### SERVICE BULLETIN REVISION TRANSMITTAL SHEET

TITLE: AIR CONDITIONING - PACK COOLING AIR CONTROL - INTRODUCE LOGIC RELAY FOR

MODIFICATION No.: 27993P5459

This page transmits Revision No. 03 of Service Bulletin No. A320-21-1121.

Figure 1 Sheet 1 Modify the Equipment in the Shelf 95VU in the FWD Electronics Rack 90VU (Goto A3 section)

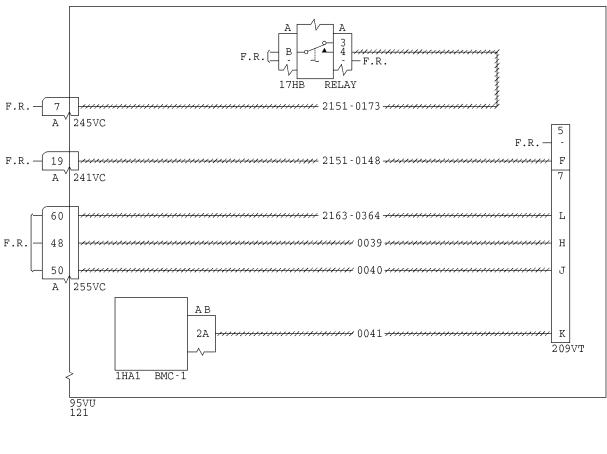
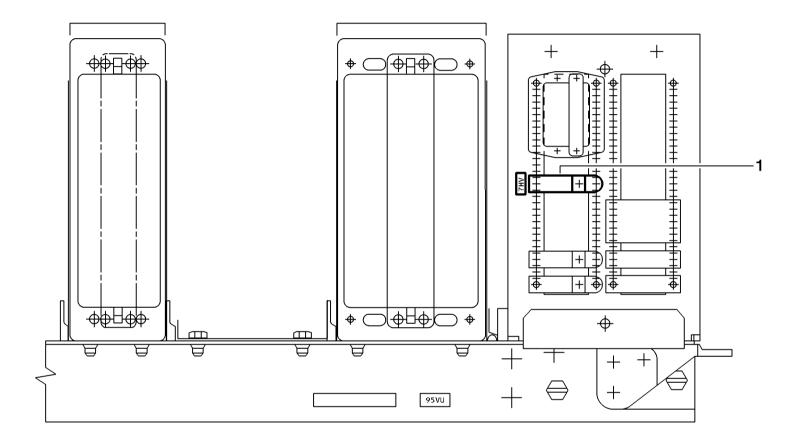
- 2 Remove the Shelf 95VU and install it on the work bench
  - $\underline{a}$  Install the relay 7HV:

1 Relay E0245-28A0 Item 1

Adjacent to the relay, in front and at the rear of it, bond the placard identified 7HV, supplied in:

Figure 3 Sheet 1 Modify the Wiring between the 95VU and the 70VU (Config. 01)

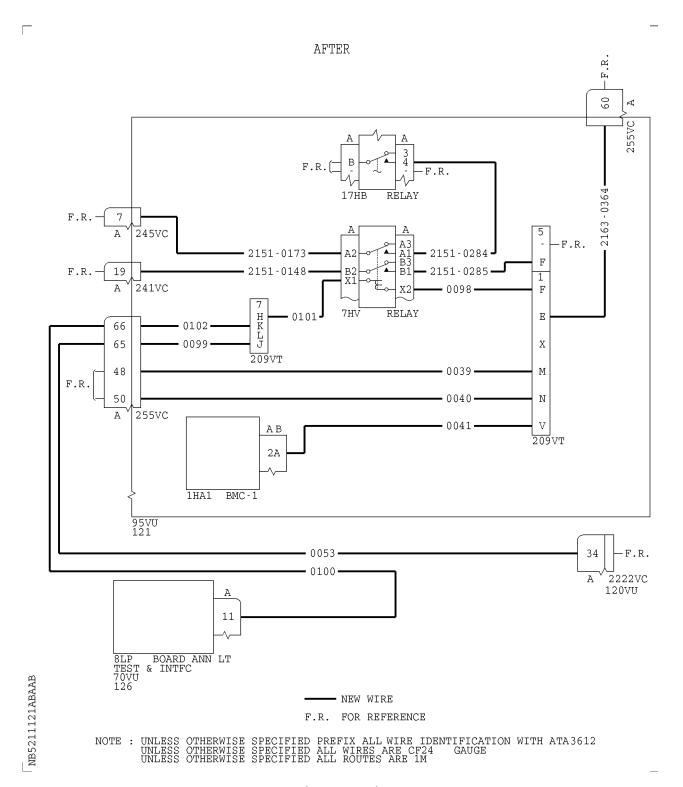
(b) Modify the wiring between the Shelf 95VU in the FWD Electronics Rack 90VU and the Annunciator Light Test Unit 70VU

$\underline{1}$  Remove the wires shown on the line 7 (Refer to figure 6).

2 Install the wires shown on the lines 23 thru 24 (Refer to figure 6 ), supplied in :

Figure 4 Sheet 1
Modify the Wiring in the Shelf 95VU in the FWD Electronics Rack 90VU
(Config. 02)

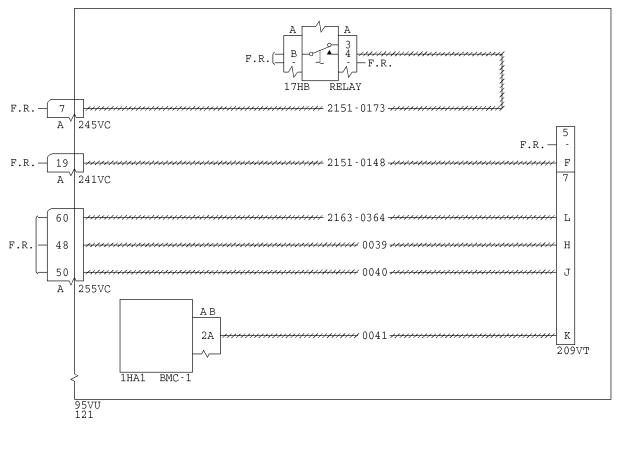
<u>b</u> Modify the wiring in the Shelf 95VU in the FWD Electronics Rack 90VU

- Remove the wires shown on the lines 1 thru 6 (Refer to figure 7).
- Install the wires shown on the lines 11 thru 22 (Refer to figure 7), supplied in:

Figure 5 Sheet 1 Modify the Wiring between the 95VU and the 70VU (Config. 02)

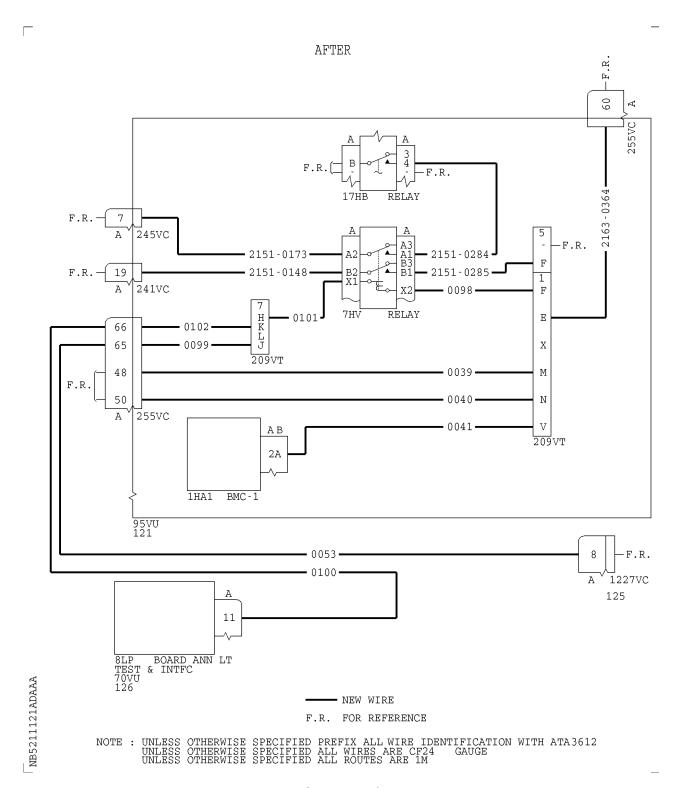
(b) Modify the wiring between the Shelf 95VU in the FWD Electronics Rack 90VU and the Annunciator Light Test Unit 70VU

- $\underline{1}$  Remove the wires shown on the line 7 (Refer to figure 7).
- 2 Install the wires shown on the lines 23 thru 24 (Refer to figure 7), supplied in:
